**Gainesville Regional Utilities
Comments to Koppers Design Track 2
Pre Design Investigation Work Plan
June 26, 2015**

GRU has the following comments to the May 13, 2015 “Pre-Design Investigation Work Plan: Design Track 2 for the Cabot/Koppers Superfund Site in Gainesville, Alachua County, Florida.”

TITLE: FULL-SCALE ISGS INJECTION-POINT LOCATIONS FOR FINAL REMEDIATION DESIGN		
LOCATION: Cabot Carbon/Koppers Superfund Site Gainesville, Florida		
	CHECKED: JE DRAFTED: CP/ld PROJ. #: 117-2201303 DATE: 4-2-15	FIGURE: 3-2

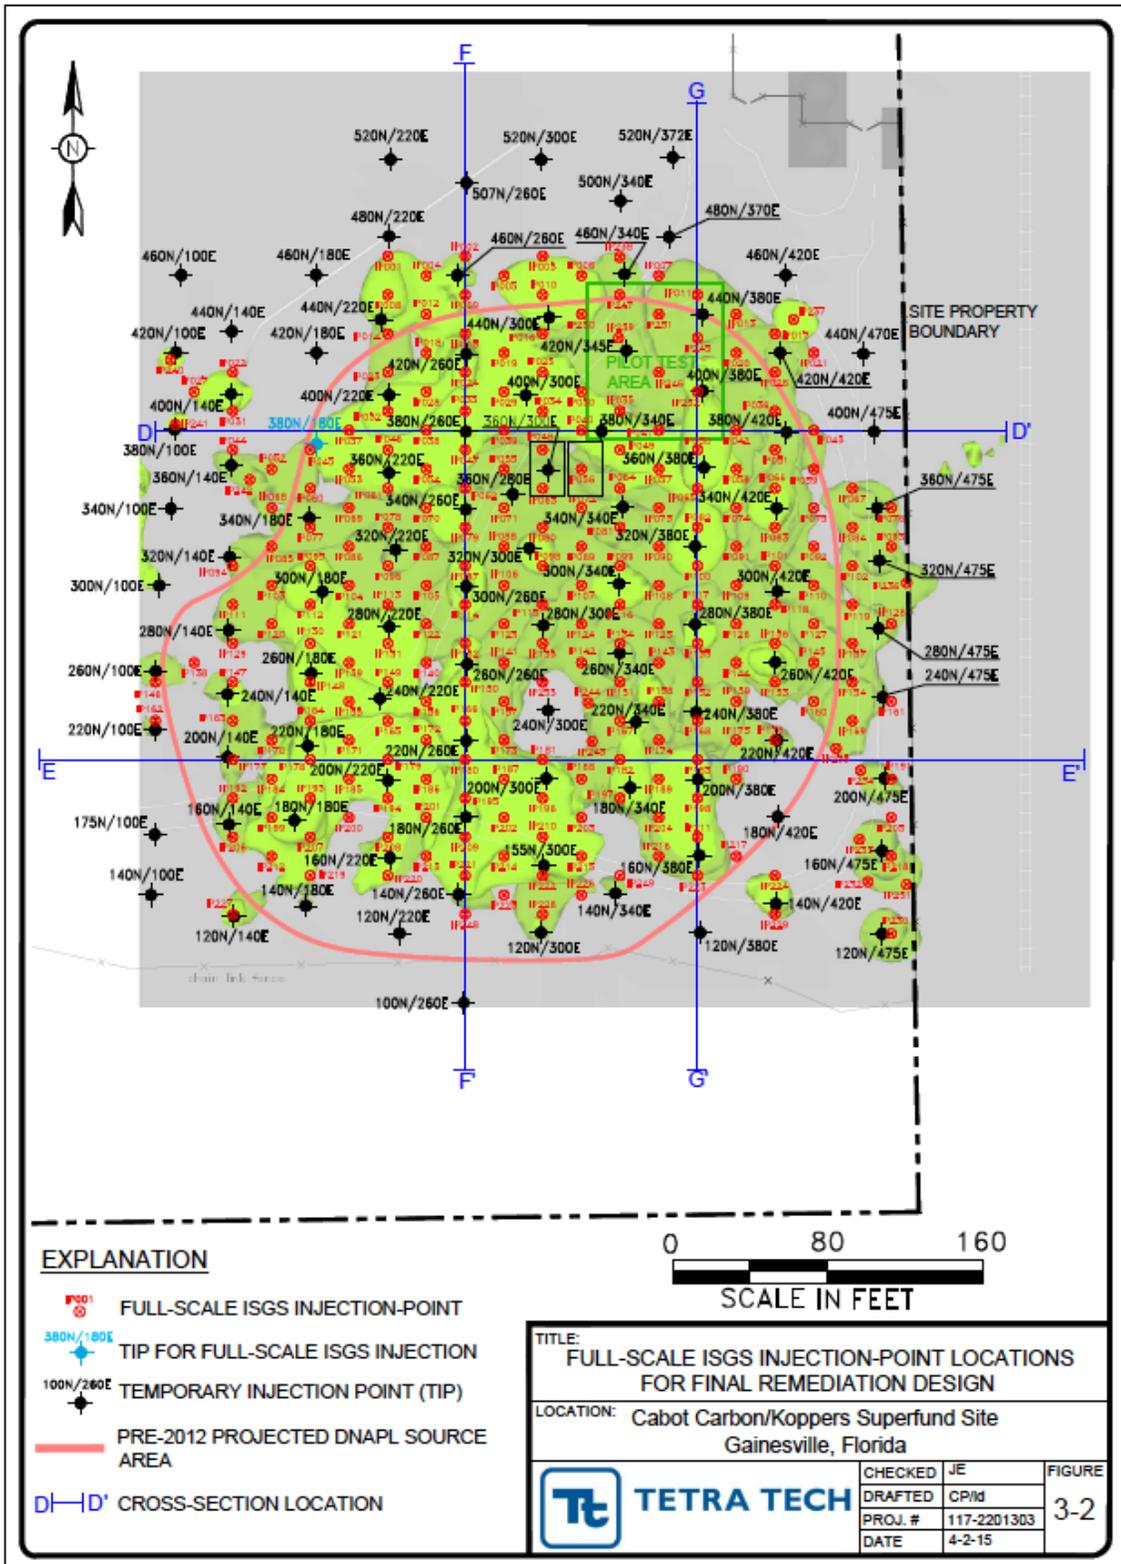
1. Section 1.4.1 (p. 7) - The work plan states “The cutoff wall will completely encircle the four principal DNAPL source areas at the Property and adjacent areas with the highest groundwater concentrations, creating a groundwater containment zone.” The currently mapped source area boundaries are based on incomplete characterization. For example, after additional characterization at the Former Process Area, DNAPL was confirmed outside the originally mapped source area boundary to the north, east, and west (see TetraTech Figure 3-2 from the Pre Final Design Report dated April 20, 2015 and presented on the last page of these comments). GRU believes the location of the cutoff wall, as currently envisioned, will likely leave high COC concentrations in groundwater – and quite possibly DNAPL - outside the cutoff wall enclosure. GRU believes that all source areas boundaries should be fully characterized before slurry wall design is conducted in those areas where the proposed cutoff wall alignment approaches the currently depicted source area boundary.

Drilling of the cutoff wall characterization borings will presumably be conducted after characterization borings are drilled for the source areas – certainly after drilling of the former South Lagoon characterization borings in preparation for ISGS treatment. The cutoff wall alignment and boring locations should be adjusted based on pre-treatment investigations of the source areas – so category 4 or 5 DNAPL should not be observed in any of the cutoff wall characterization borings. A detailed re-evaluation of DNAPL distribution will be warranted if category 4 or 5 DNAPL is observed in a cutoff wall characterization boring.
